ADDENDUM #3

GADSDEN CITY HALL

Gadsden, AL WBA #23-083.00

DATE: 13 December 2024

SHEET NUMBER:
A-125

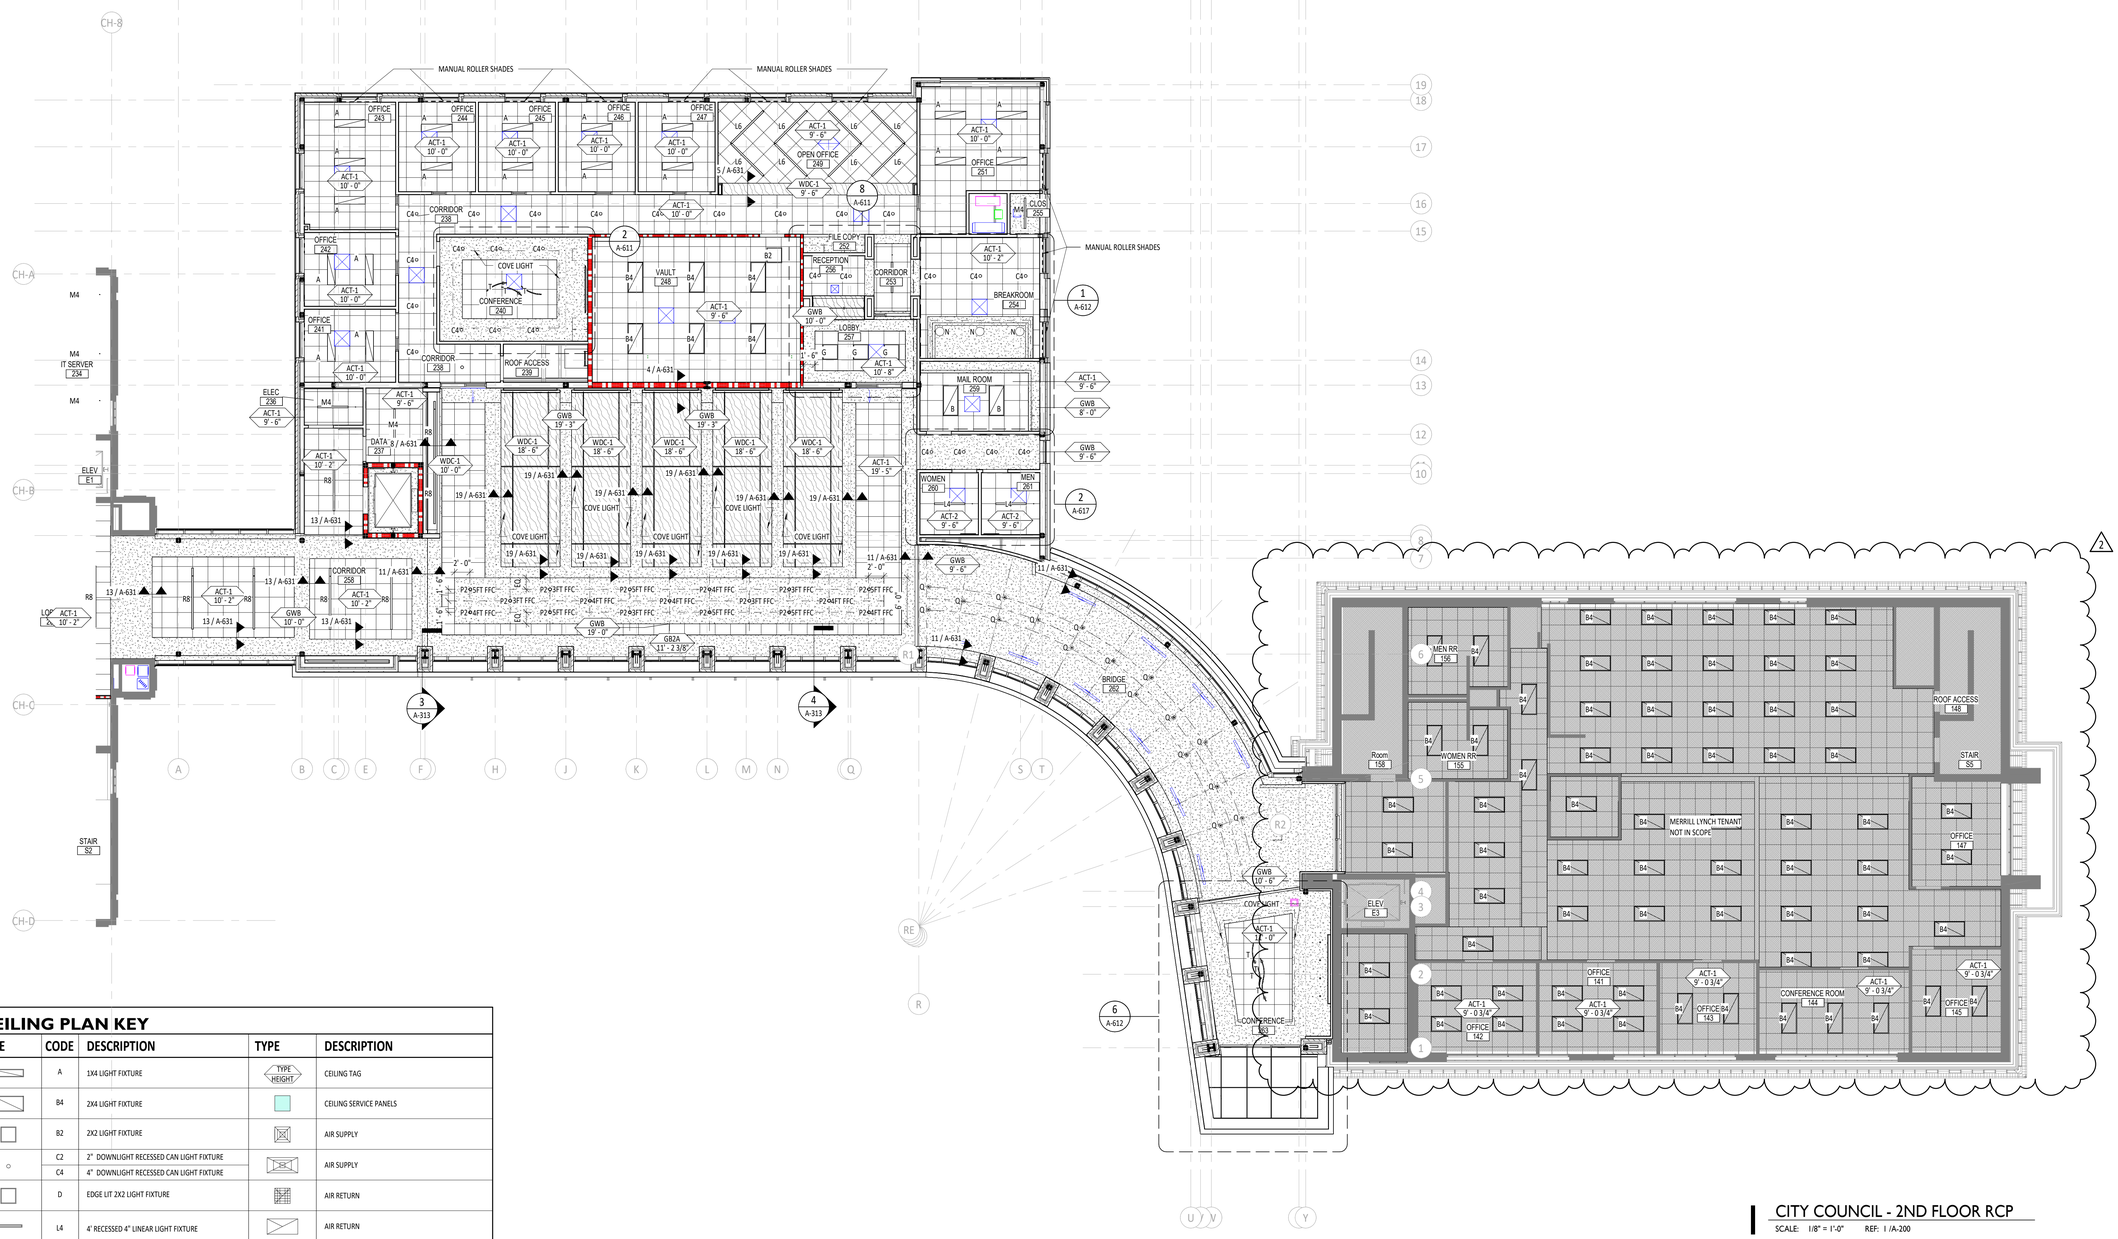
27. **Sheet A-125 – 2nd FLOOR RCP – CITY COUNCIL:**
    a. Added shaded region and “MERRILL LYNCH TENANT NOT IN SCOPE” in the RCPs for clarification.
    b. See attachments.

SHEET NUMBER:
A-202

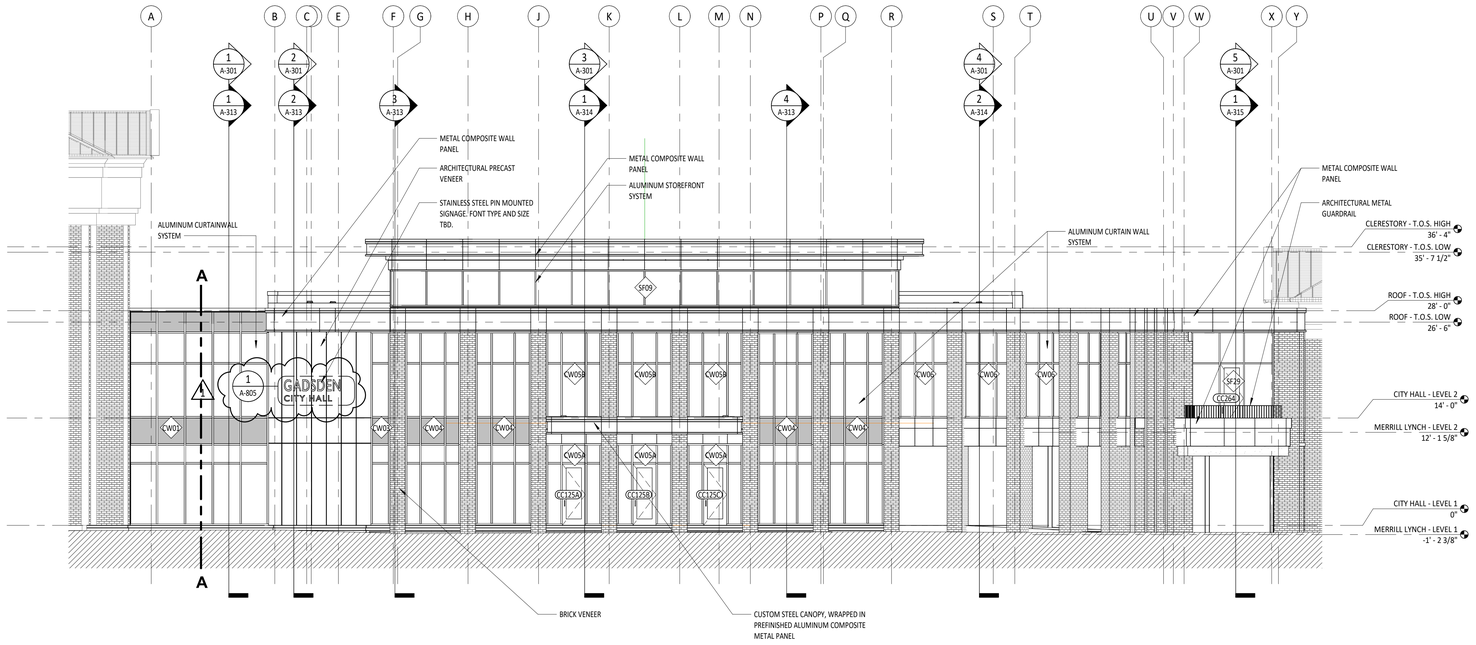
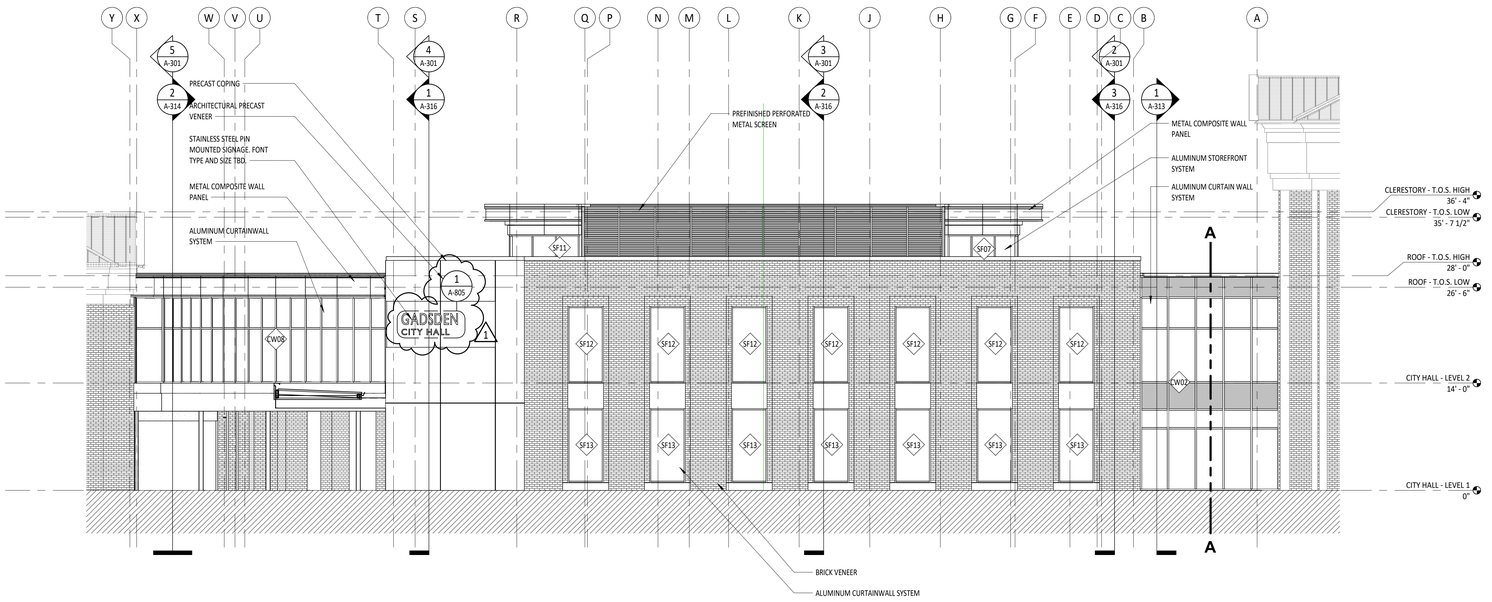
28. **Sheet A-202 – EXTERIOR ELEVATIONS – CITY COUNCIL:**
    a. Drawing 1/A-202 – CITY COUNCIL – SOUTH ELEVATION: Added callout for sheet A-805 – SIGNAGE DETAILS & ELEVATIONS.
    b. Drawing 2/A-202 – CITY COUNCIL – NORTH ELEVATION: Added callout for sheet A-805 – SIGNAGE DETAILS & ELEVATIONS.
    c. See attachments.

ENLARGED FLOOR PLAN - COUNCIL OF CHAMBERS

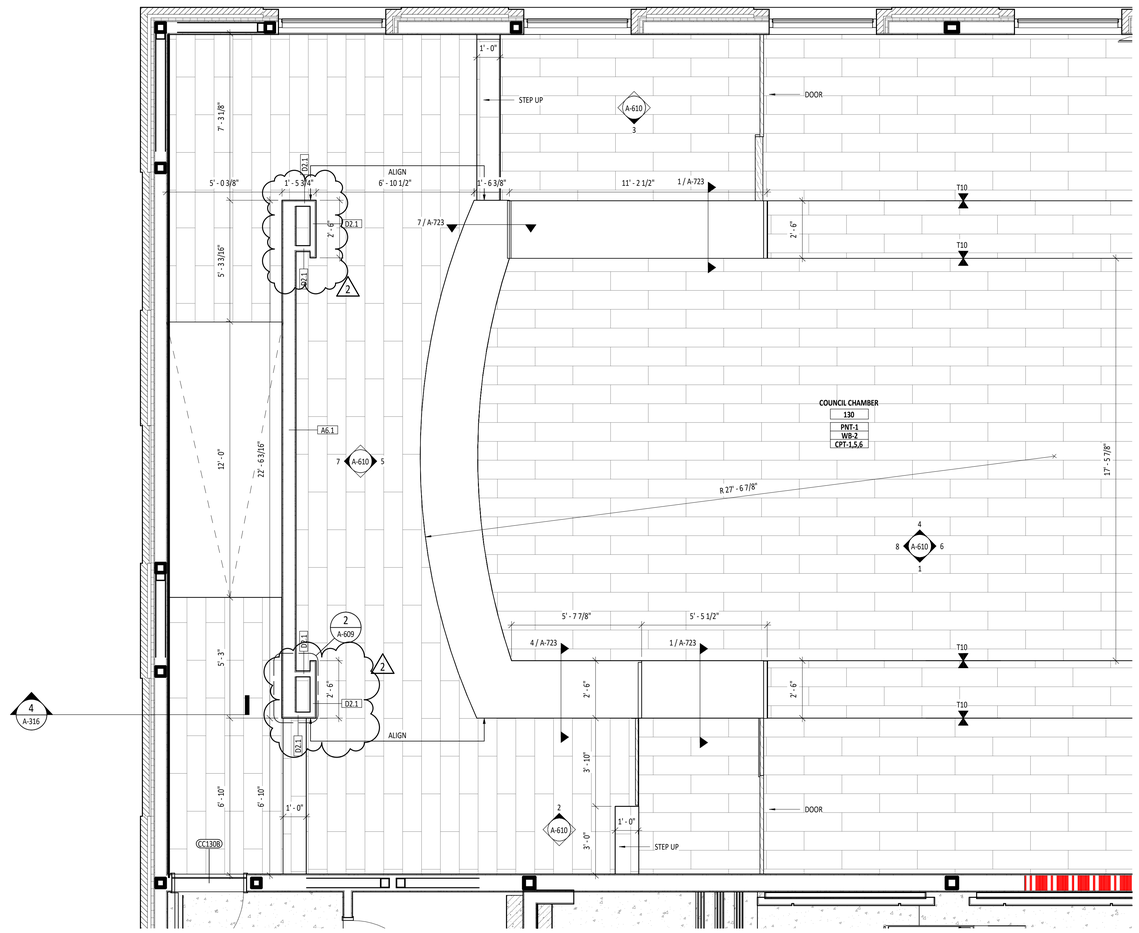
30. **Sheet A-609 – CC – 1st FLOOR ENLARGED PLANS & ELEVATIONS:**
    a. Drawing 1/A-609 ENLARGED FLOOR PLAN – COUNCIL OF CHAMBERS: Revised dimensions on pilasters to accommodate rain leader.
    b. Drawing 2/A-609 PLAN DTL – COUNCIL OF CHAMBERS PILASTER: Revised detail to show clear dimension within pilaster to accommodate rain leader.
    c. See attachments.

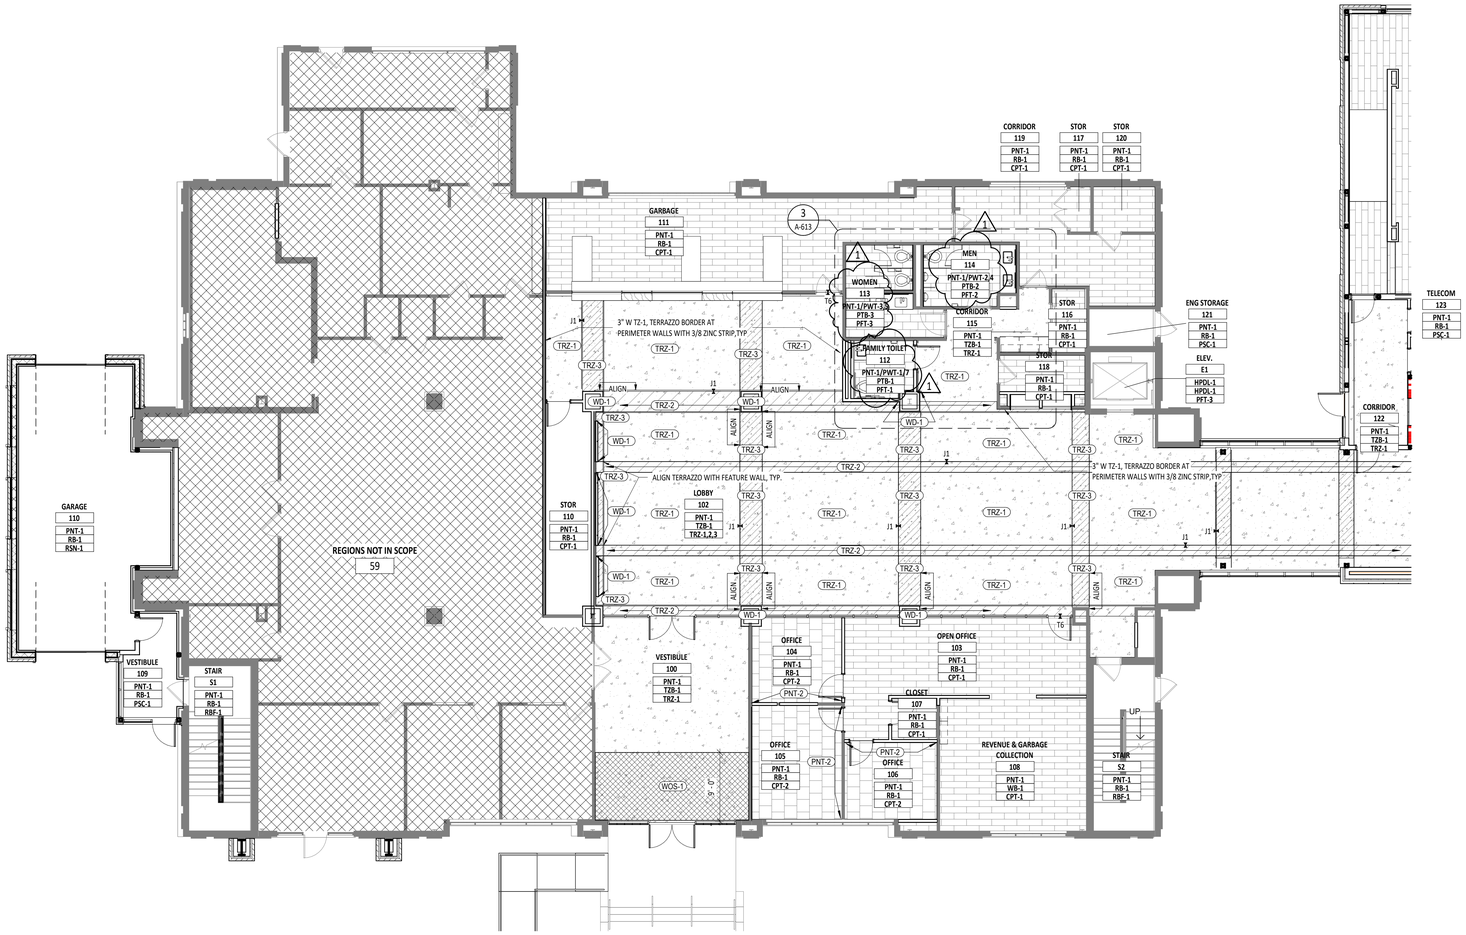
34. **Sheet A-701 – 1st FLOOR FINISH PLANS – CITY HALL:**
    a. Revision clouds were not shown in Addendum #2 – Sheet has been included for clarity purposes only.
    b. Drawing 1/A-701 – CITY HALL – 1st FLOOR FINISH PLAN:
        i. FAMILY TOILET 112 – Updated finish tag.
        ii. WOMEN 113 – Updated finish tag.
        iii. MEN 114 – Updated finish tag.

2 STOREFRONT ELEVATIONS

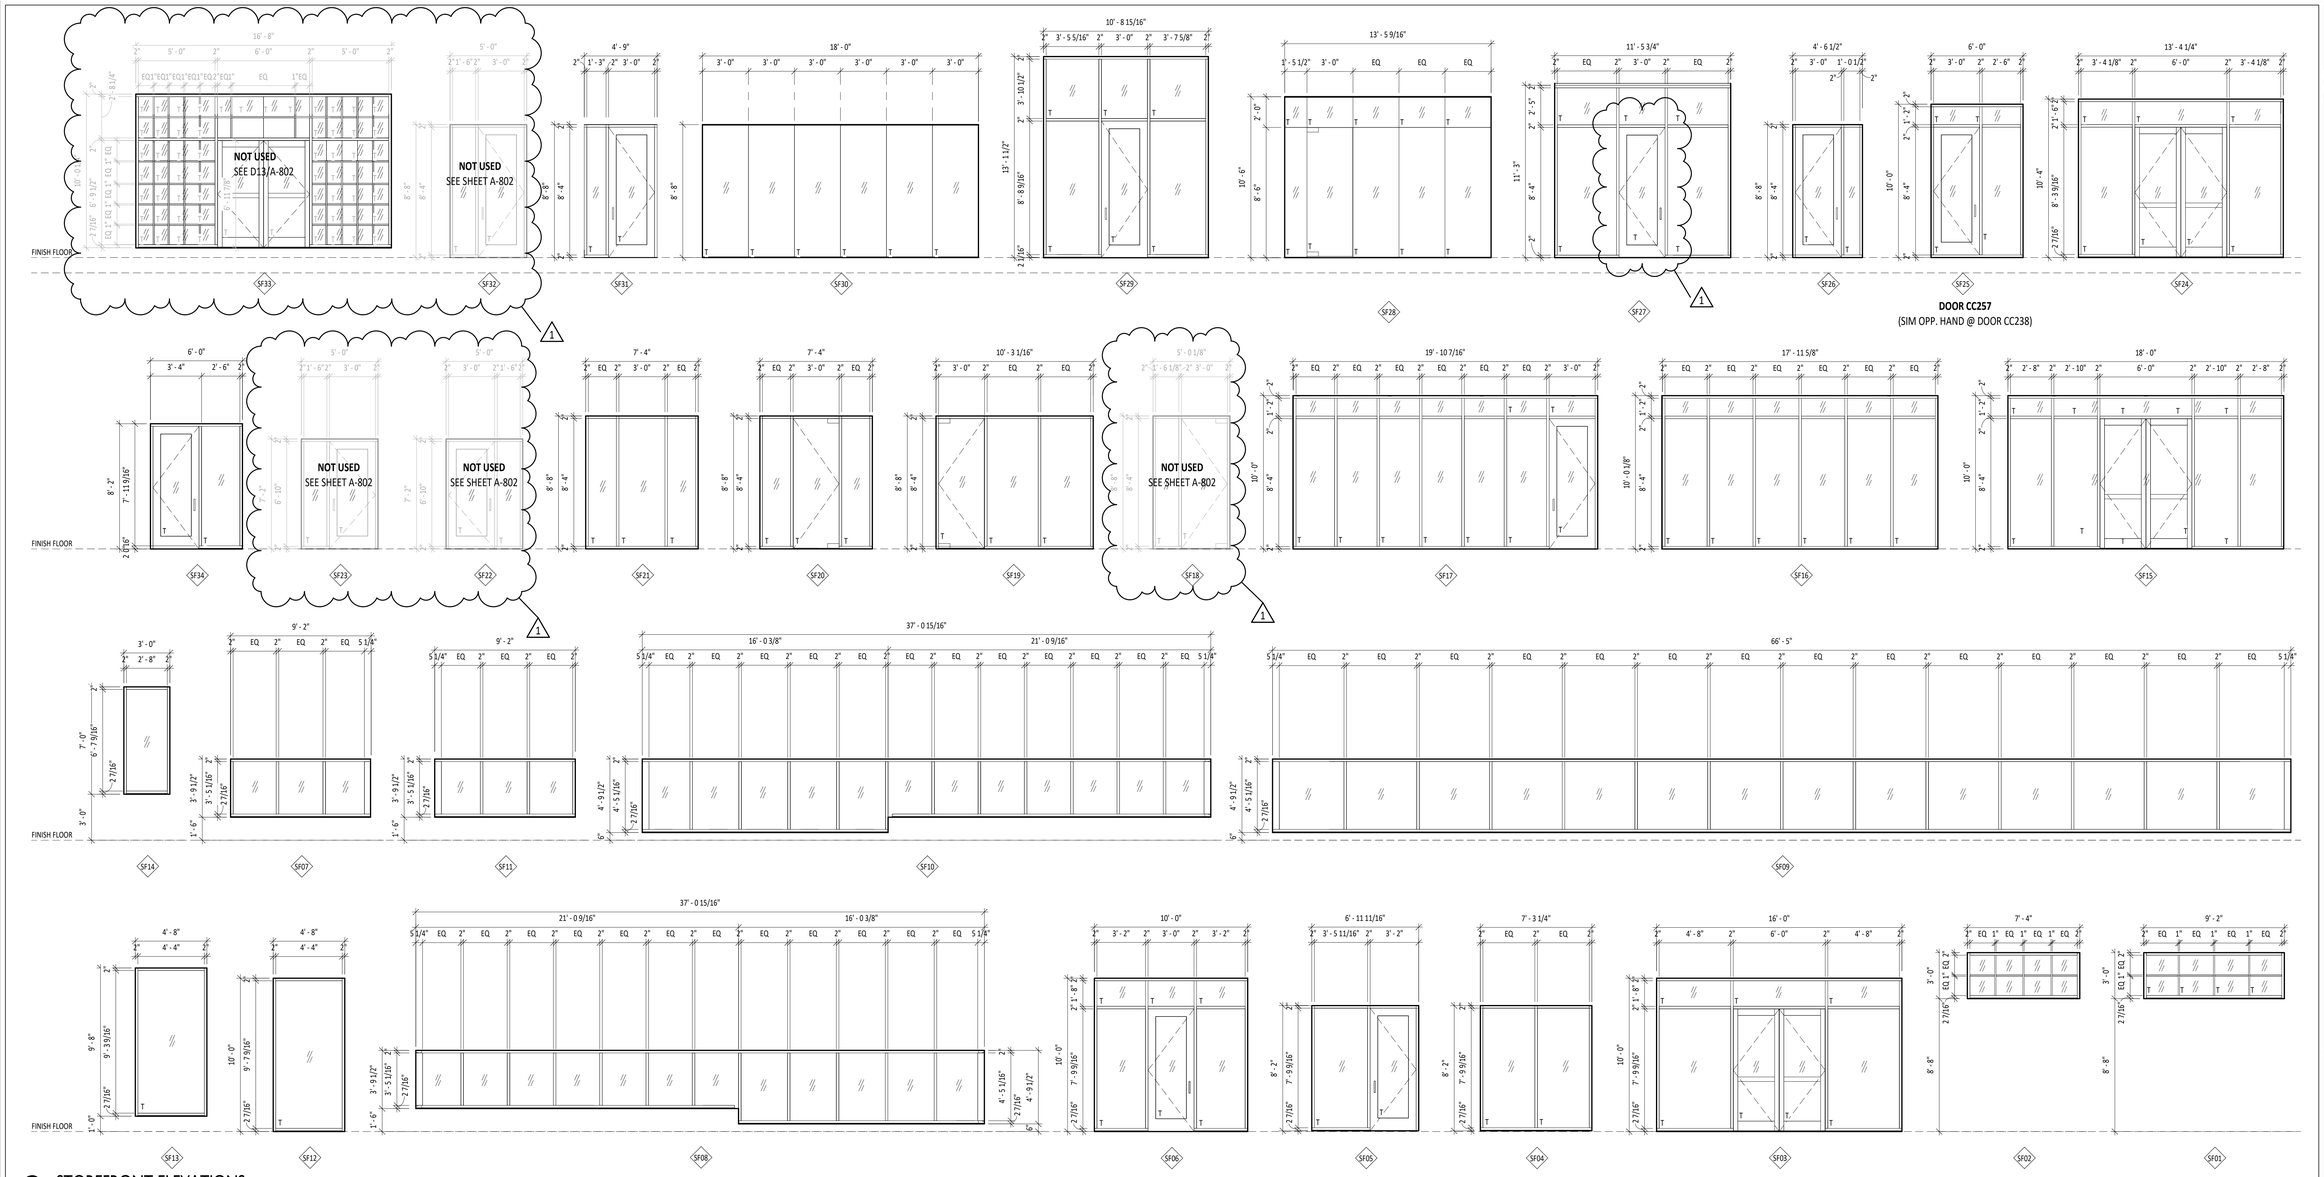
a. Drawing 2/A-803 – STOREFRONT ELEVATIONS: Revised SF18, SF22, SF23, SF32 and SF33 to be "NOT USED". Refer to door schedule for frame types at these locations. Revised door type in SF27.
b. See attachments.
